**SUBDIVISION,
PLANNED UNIT DEVELOPMENT,
PLANNING APPROVAL,
ZONING AMENDMENT &
SIDEWALK WAIVER STAFF REPORT****Date: March 4, 2021**

<u>NAME</u>	Big River Partners (Casey Pipes, Agent)
<u>SUBDIVISION NAME</u>	Feeder Springs Subdivision
<u>LOCATION</u>	3905 Dauphin Street and 220 & 226 South McGregor Avenue (Southeast corner of South McGregor Avenue and Dauphin Street).
<u>CITY COUNCIL DISTRICT</u>	District 5
<u>PRESENT ZONING</u>	R-1, Single-Family Residential District
<u>PROPOSED ZONING</u>	R-3, Multi-Family Residential District
<u>AREA OF PROPERTY</u>	1 Lot / 10.8± Acres
<u>CONTEMPLATED USE</u>	<p>Subdivision approval to create one (1) legal lot of record from seven (7) legal lots of record and one (1) metes-and-bounds parcel; Planned Unit Development Approval to allow multiple buildings on a single building site; Planning Approval to allow a domiciliary care facility and nursing home in an R-3, Multi-Family Residential District; Rezoning from R-1, Single-Family Residential District, to R-3, Multi-Family Residential District; and Sidewalk Waiver approval to waive construction of a sidewalk along South McGregor Avenue.</p> <p>It should be noted, however, that any use permitted in

SITE PLAN

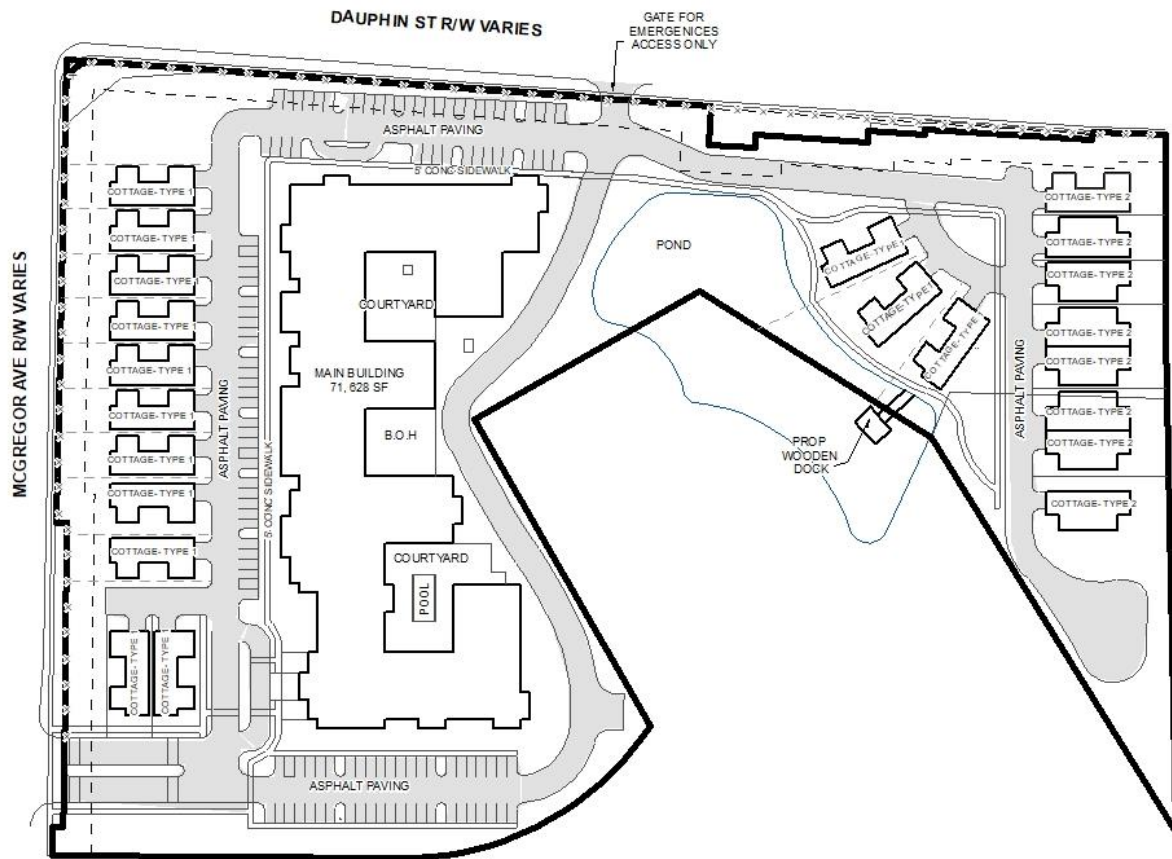
The site plan as submitted has a few items that need to be addressed. The site plan depicts fencing along Dauphin Street and South McGregor Avenue, but does not mention the height or material of the fence. Furthermore, a portion of the fence along Dauphin Street is depicted in the right-of-way. If approved, the fence should be relocated to be on private property, or a non-utility-right-of-way use agreement will be required to allow the fencing in the right-of-way.

As mentioned previously, a residential buffer should be provided for adjacent R-1 properties, and should be depicted on the site plan, if approved.

The site has frontage on a small body of water, and the site plan shows a proposed wooden dock for residents to utilize. It is important to note, however, that the proposed dock is shown as crossing the property line, and would therefore extend onto property not owned by the applicant. If approved, the dock should be relocated to be located entirely on the applicant's property, or should be removed.

There is a note on the site plan stating that dumpster pads will be connected to sanitary sewer and have a compliant enclosure, but no dumpsters are actually illustrated on the site plan. If approved, any dumpsters proposed to be on the property should be illustrated on the site plan.

The site plan has notes indicating the front, side, and rear setbacks; however, the side and rear setbacks are both listed incorrectly as eight feet. As the site will abut R-1 zoning on the sides and rear, the site plan should be revised to state these setbacks are ten feet, if approved.

The 25' minimum building setback is depicted along all frontages for the proposed Lot A. It should be noted however, that the setback line does not follow the proposed property line at the intersection where dedication is to be made. If approved, the setback line should be revised to follow all property lines, adjusted for dedication.
